Access Compliance Report

Public Rights-of-Way

(Curb Ramps)

Intersection ID: 2544	Main Street: HARTFIELD_DOWNS_DR	Cross Street: HIGHLAND_CREEK_PY	Location: NW
ADA ID: EFAED78FC172	Ramp Type: Perp	Initial Pass/Fail: Fail	Overall Compliance: No
Severity Score: 8.75			
Codes/Mitigation Info/Possible Solution		Field Measurements/Component Compliance

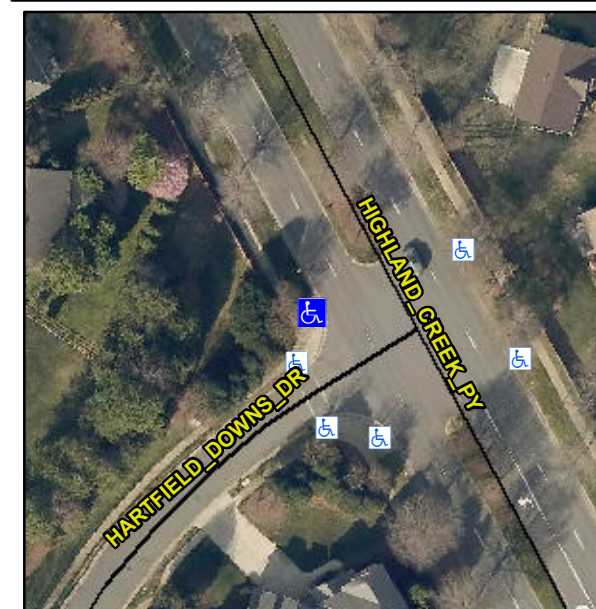
R304.5.1

Compliance	Description	Data	Compliance	Description	Data
N/A	Ramp Length (in)	131.0	Yes	Ramp Slope (%)	5.1
No	Ramp Width (in)	39.0	Yes	Ramp XSlope (%)	1.5
N/A	Flare Type LT	N/A	N/A	Flare Type RT	N/A
N/A	Flare Slope LT (%)	N/A	N/A	Flare Slope RT (%)	N/A
N/A	Flare Traversable LT?	N/A	N/A	Flare Traversable RT?	N/A
N/A	Landing Length (in)	N/A	N/A	DWS Provided?	N/A
N/A	Landing Width (in)	N/A	N/A	DWS Contrast?	N/A
N/A	Landing Slope (%)	N/A	N/A	DWS Length (in)	N/A
N/A	Landing X Slope (%)	N/A	N/A	DWS Full Width?	N/A
N/A	Landing Curb? (Y/N)	N/A	N/A	DWS Offset (in)	N/A
N/A	Shared Landing?	N/A			
N/A	Gutter Ponding?	N/A	N/A	Gutter Slope (%)	N/A
N/A	Gutter Lip Ht (in)	N/A	N/A	Gutter X Slope (%)	N/A
N/A	Painted X Walk1?	No	N/A	Painted X Walk2?	N/A
	X Walk 1 Direction	To E		X Walk 2 Direction	N/A
N/A	X Walk 1 Width (in)	N/A	N/A	X Walk 2 Width (in)	N/A
	X Walk 1 Slope (%)	2.7		X Walk 2 Slope (%)	N/A
	X Walk 1 X Slope (%)	1.7		X Walk 2 X Slope (%)	N/A

Remove & Replace Entire Ramp.
